JUDGE DOYLE SQUARE - BLOCK 88 DESIGN ALTERATIONS - PEDESTRIAN PARKING GARAGE ENTRY

City of Madison
Public Parking & Podium - Phase 1 SIP

OCTOBER 03, 2018

The following pages are a response to the comments provided by the Urban Design Commission on September 26, 2018. Pages 4-16-A.1 through 4-16-A.7 exhibit two options that we feel acknowledge the concerns expressed by the committee members. All previously submitted sheets that contain the pedestrian garage entry on Doty Street and Wilson Street, would be superseded by the option that is deemed acceptable by the UDC.

ORIGINAL

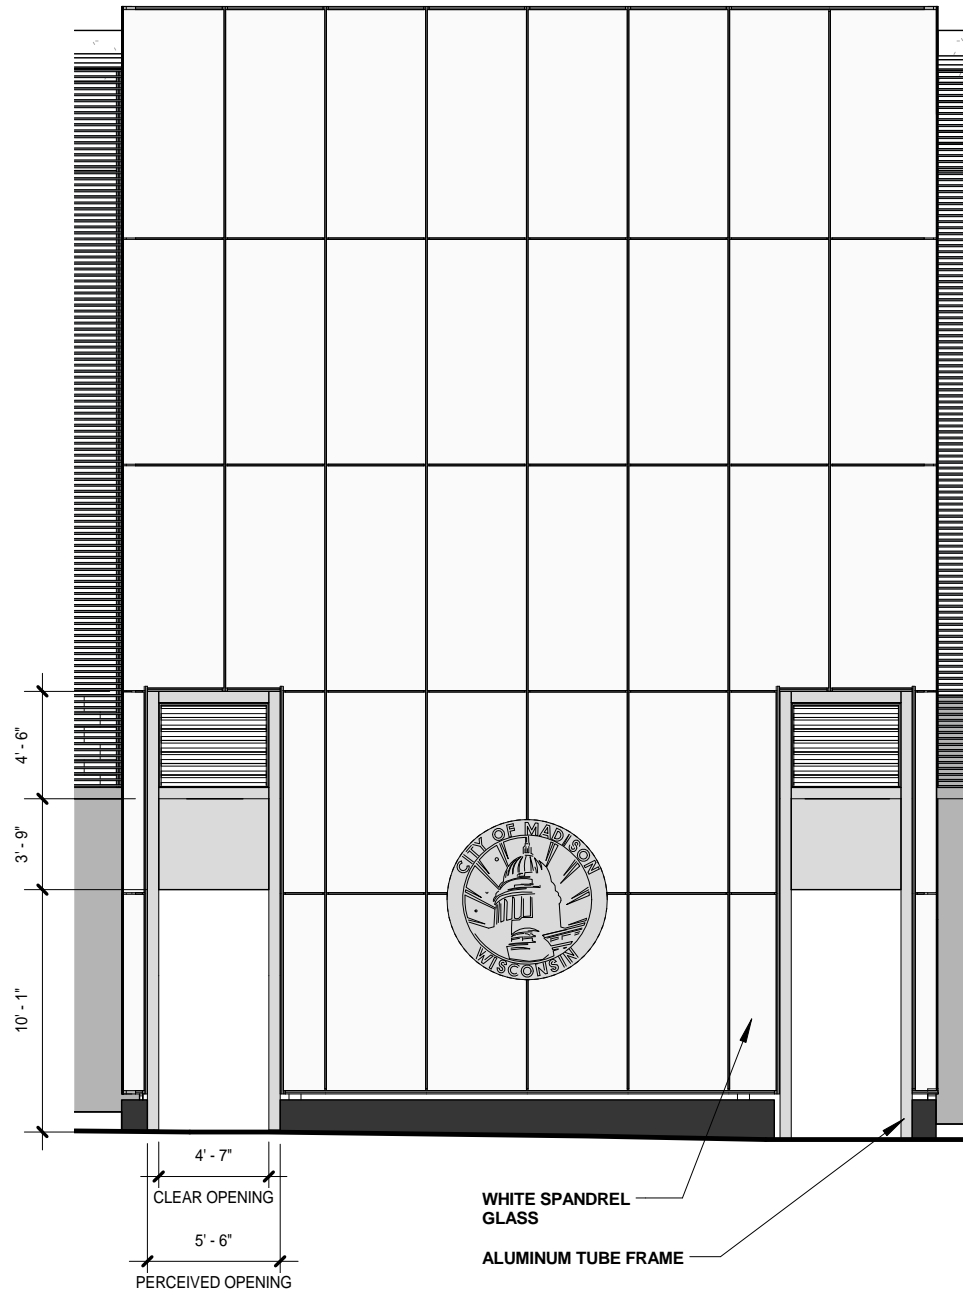
DESCRIPTION: This option was previously presented at the UDC meeting on 09/26/2018. The commission was concerned about the proportion of the pedestrian openings versus the overall scale of the vertical white spandrel glass. This elevation is shown as a comparison for options A and B which have been created as a response to the UDC comments

OPTION A

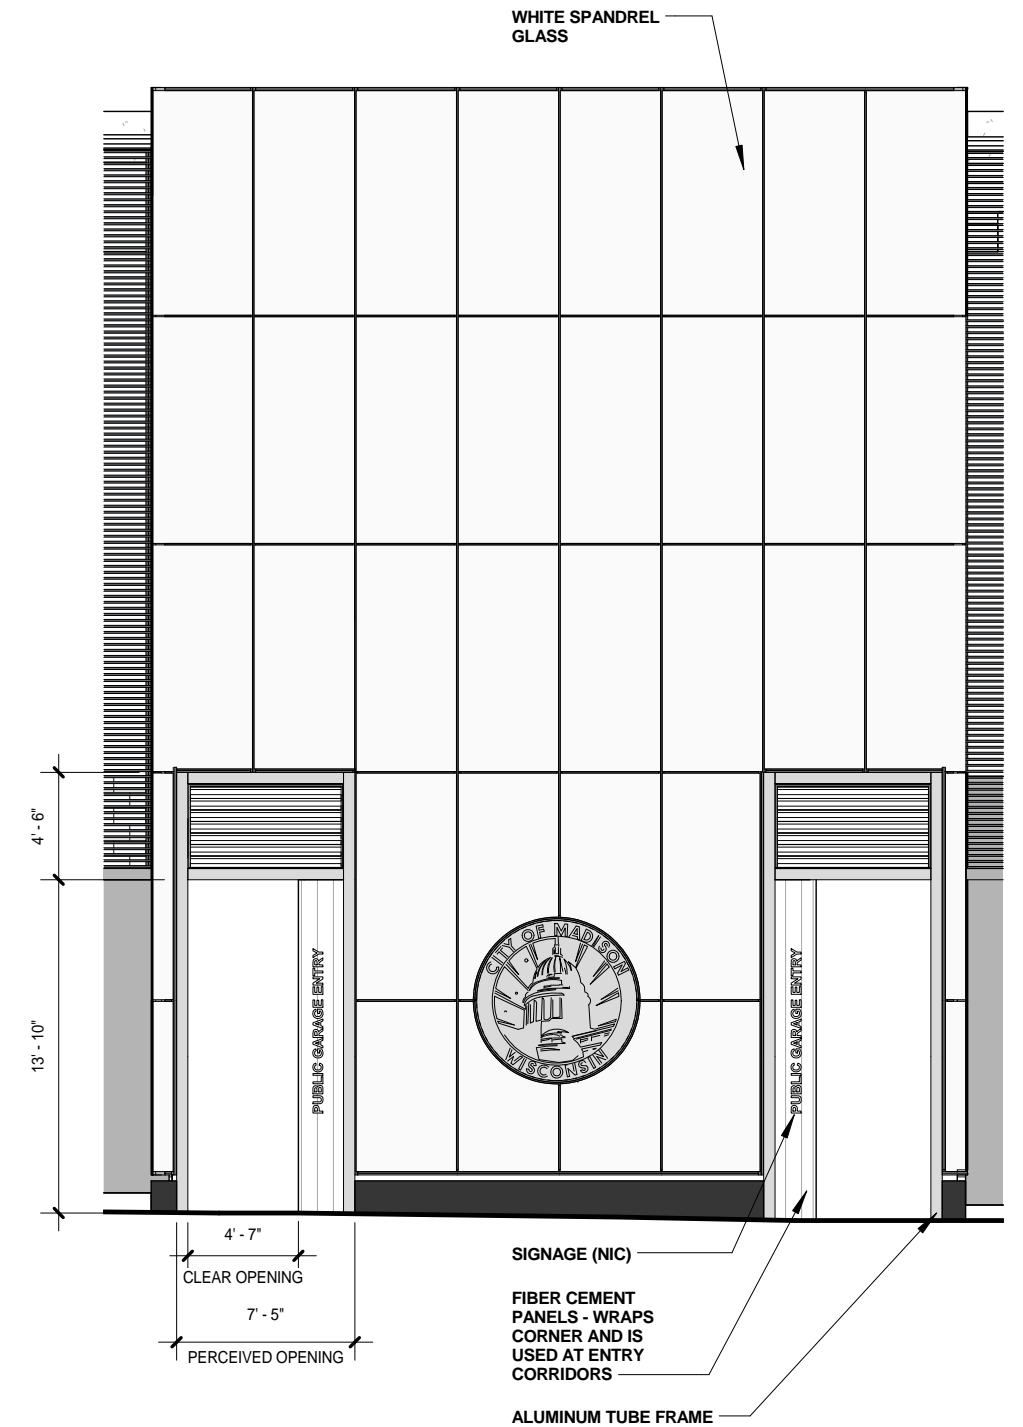
DESCRIPTION: The pedestrian entries, which originally had a clear opening of 3'-8", have been widened to 4'-7" with the total width of the perceived opening (including the aluminum frame) to be 5'-6".

OPTION B

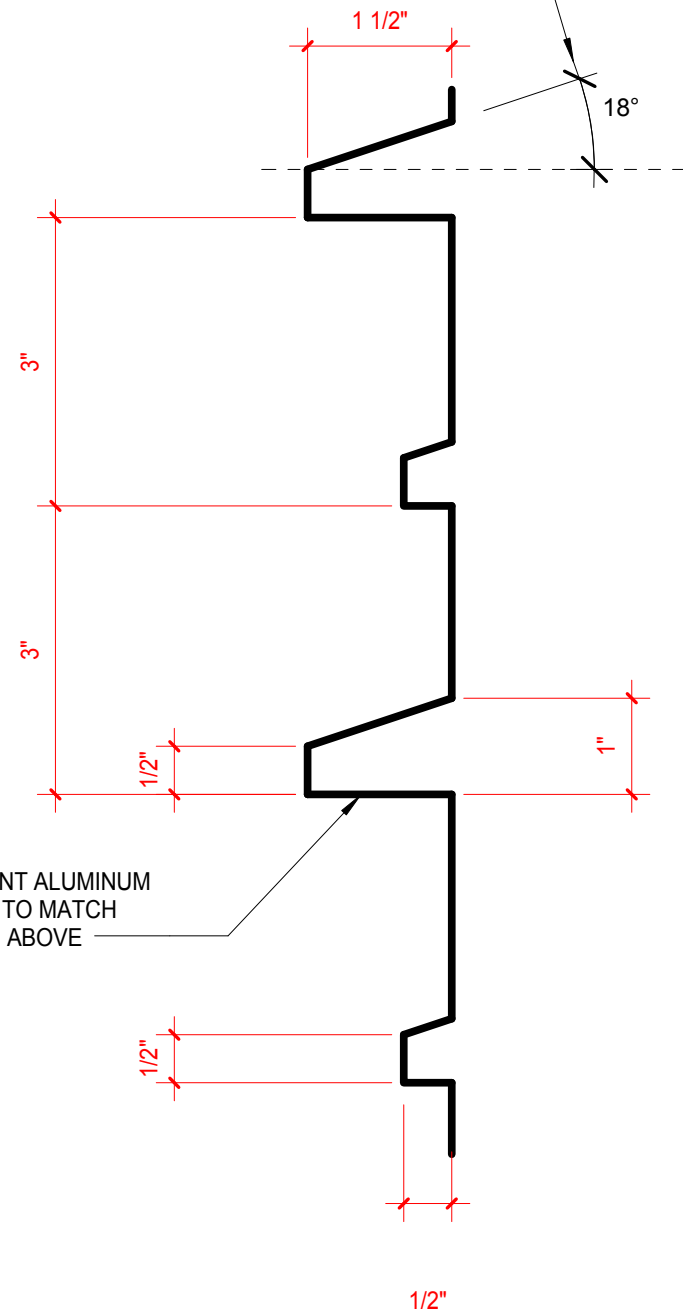
DESCRIPTION: The clear openings at the entries have been widened to 4'-7" and the total width of the perceived opening has been increased to 7'-5". The fiber cement wall panels, which were previously only on the inside of the garage, now wrap the corners of the elevator shaft wall and have a small presence on the exterior façade. These panels are inset 8" from the exterior face of the aluminum frame and have the potential to support signage options, as shown with the vertical lettering in the sketch.
